**NEW MEXICO
ENVIRONMENT DEPARTMENT**

Re: Sonoma Ranch East II/Sonoma Ranch East Phase 9; CGP; SIC 1521; NPDES Compliance Evaluation Inspection; NPDES #NMR1000NV; February 13, 2019

NPDES Construction General Permit Inspection Report – State of New Mexico

Attachment: Permittee Response

Attachment 2 – Photos - documentary

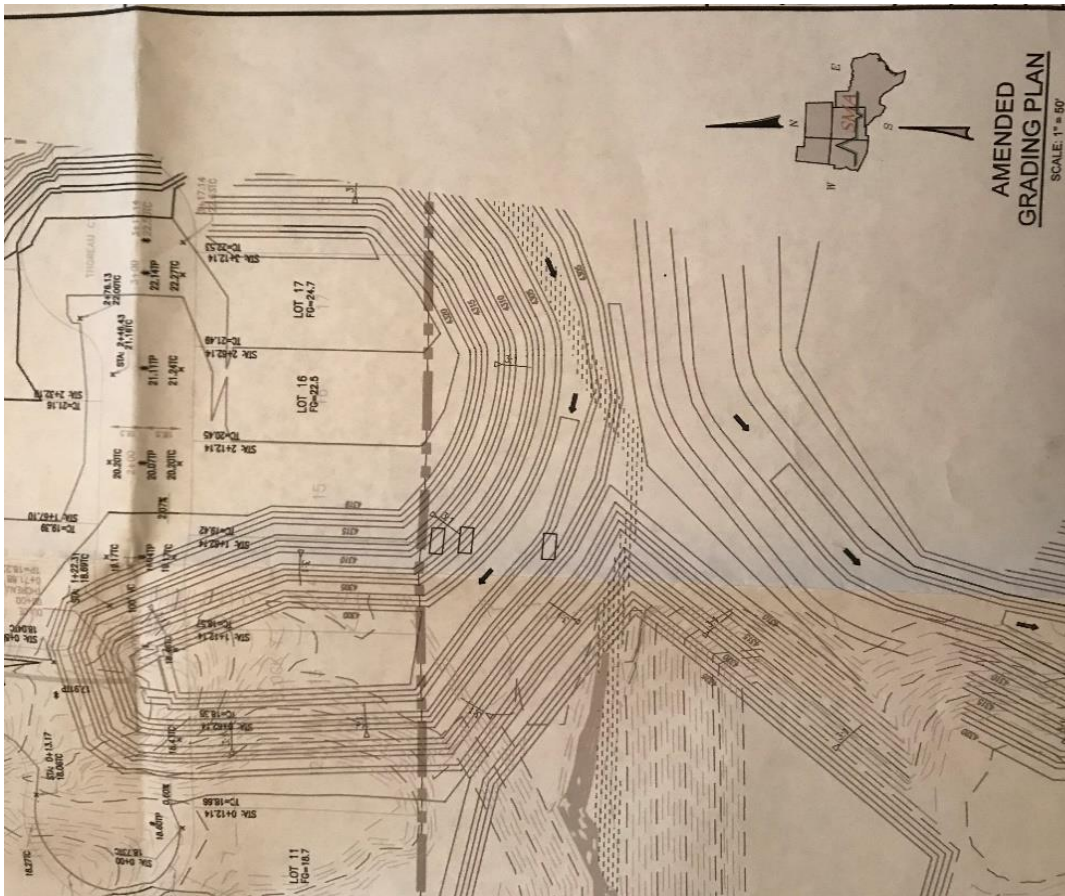
- Part 1.1.6 Historic Screening process in Appendix E was not followed.
- Part 1.5 SWPPP Public posting was missing.

- Part 2.2.1 No documentation of buffers or equivalent controls
- Part 2.2.10 Storm drain inlets not installed and sediment accumulation in storm drains must be removed.
- Part 2.2.11 erosion controls and velocity dissipation devices for stormwater conveyance channels and their embankments, outlets, adjacent streambanks, slopes, and downstream waters is inadequate.
- Part 2.2.12 No documentation of sediment basin design was available.
- Part 2.2.14 No documentation of temporary stabilization of disturbed areas.
- Part 2.2.14. a.iii No dates for initiating and completing vegetative stabilization in the plan. Permanent stabilization of the site was not initiated and temporary non-vegetative stabilization measures were not documented.
- Part 2.2.14.b Final Stabilization criteria was not met for areas not covered by permanent structures.

SWPPP Public posting (Part 1.1.6), Looking east from northwest corner

Rock velocity dissipation (Part 1.5) installed per City of Las Cruces approved plans, March 03, 2019. 15' width at outlet, 28' width at 15' distance from outlet. Boulders 2' to 3' size.

Sediment Basin excerpt from Civil Plans (Part 2.2.12). Basin is designed to pass-thru the upland stormwater and retain only the silt.

All Operators signatures on SWPP Inspections below (Part 4.7.2). These are the last 3 inspections from the original logbook, Sep/Oct 2018.
